Proposed Planning Scheme Amendment C308: Central City and Southbank Urban Design

The Victorian division of the Urban Development Institute of Australia (UDIA Victoria) welcomes the opportunity to lodge a submission in response to the proposed Planning Scheme Amendment C308 (PSA C308).

Project Title: CITY TEMPO - 361 Queen Street, Melbourne
Drawing Title: SIGNAGE DETAILS - LOCATION PLAN
Drawn by: JK
Drawing no: S-01

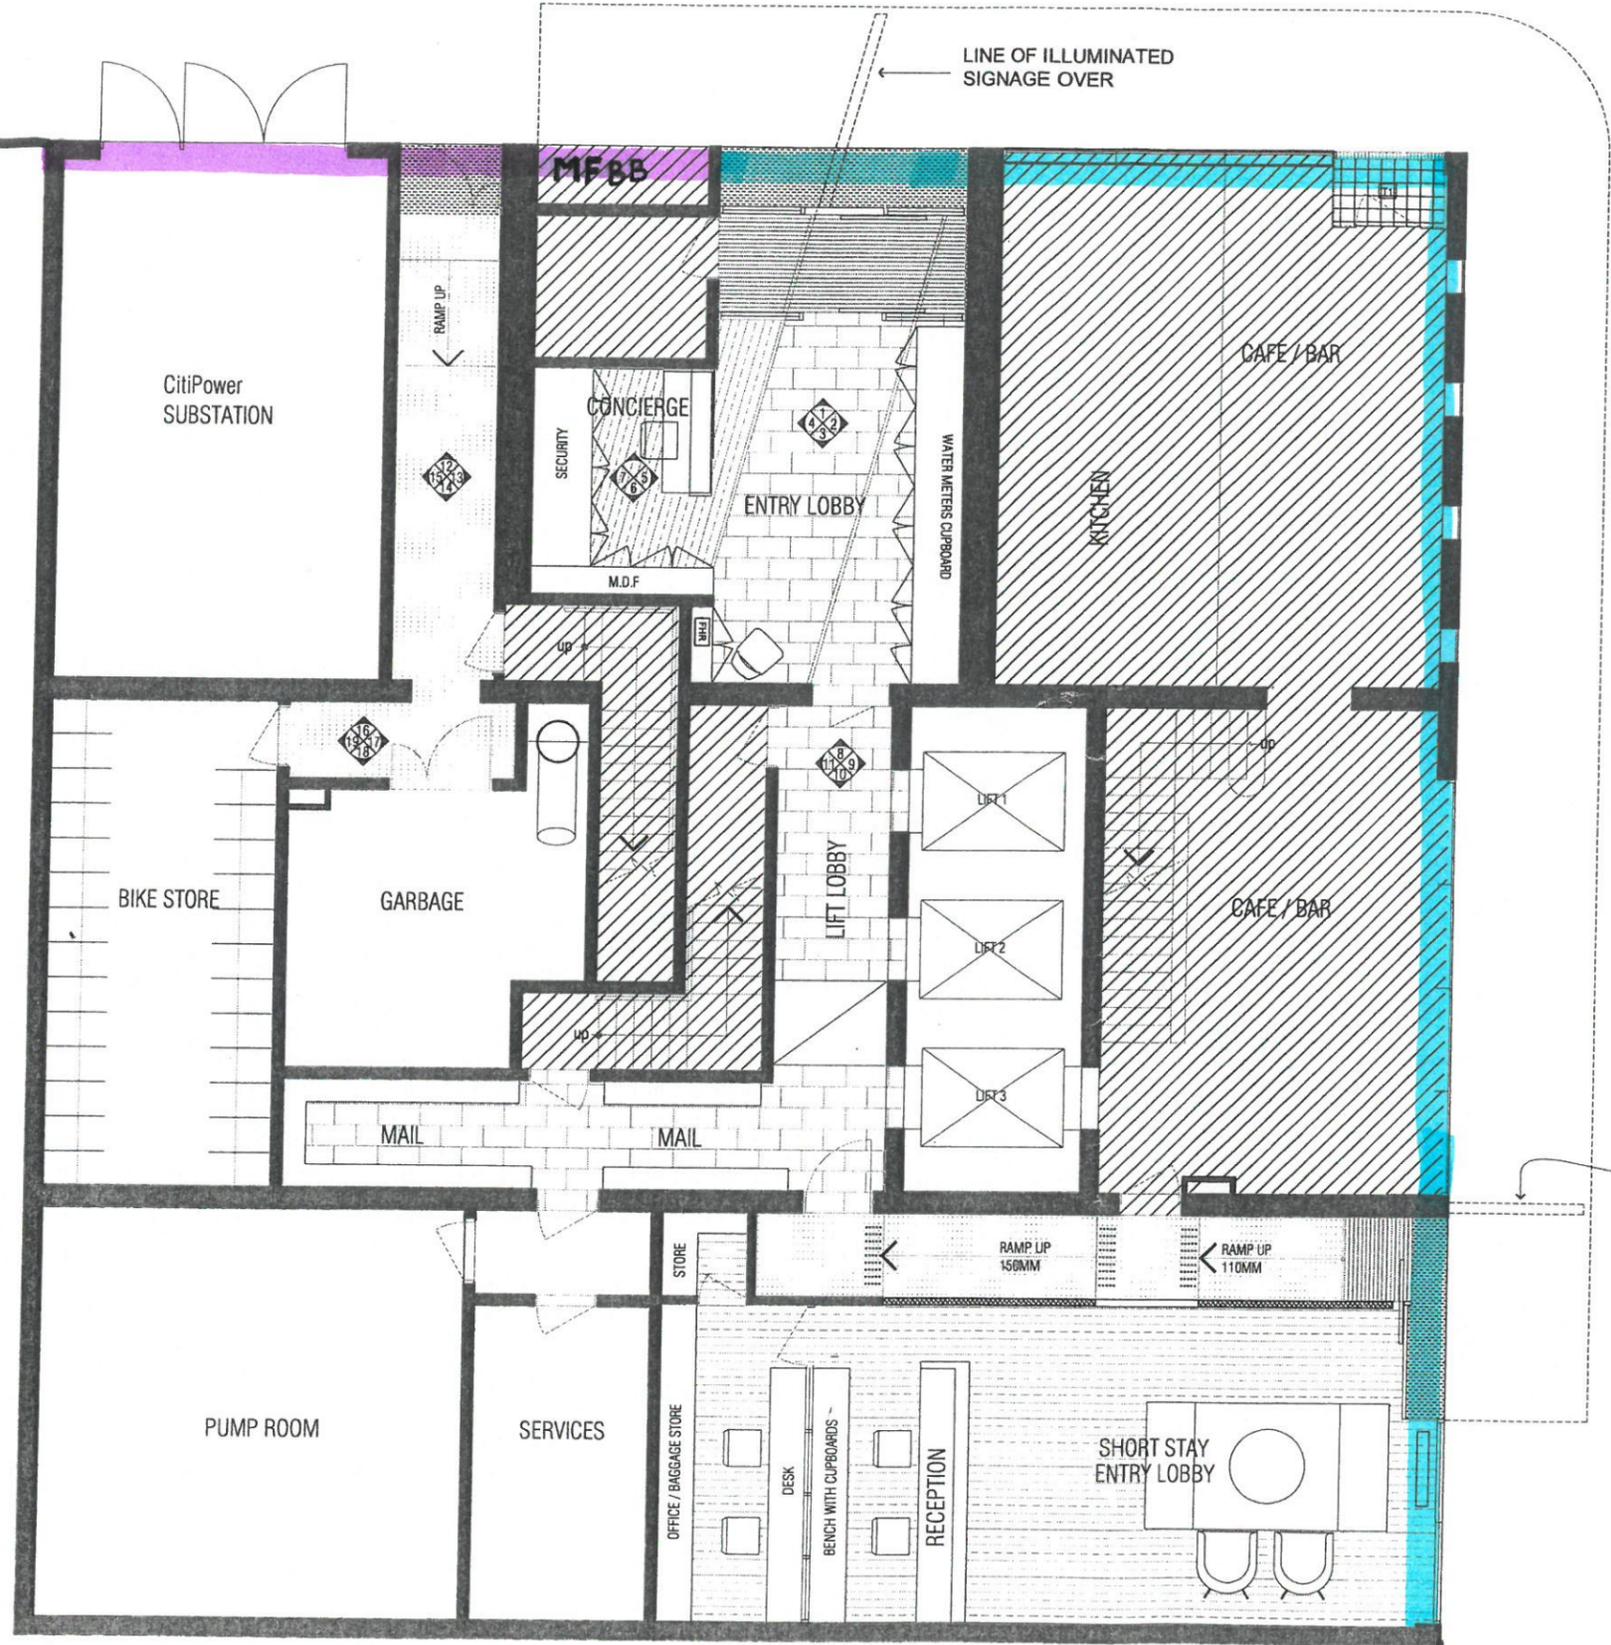
- Table 4 of DDO1 requires that at least 5 metres or 80% (whichever is the greater) of the frontage must be entry /display window in “Special Character Areas”. We note this may not be possible for smaller sites as demonstrated by the attached ground floor plan of 361 Queen Street. This site has the benefit of a corner location (two street frontages) and no carparking access is provided. The design outcome has provided the maximum active frontages possible. However, due to the provision of services to the building edge, as required by Citipower (substation), MFB (Boosters) and garbage room access (MCC), this building only achieves 77% active frontage and would be prohibited by the proposed controls if the site were located in a special character area.

5. Amend the provisions to make the requirement for at least 5 metres or 80% (whichever is the greater) of the frontage of a building in special character areas must be entry /display window to be discretionary rather than mandatory, as this may not be possible to achieve for all sites.
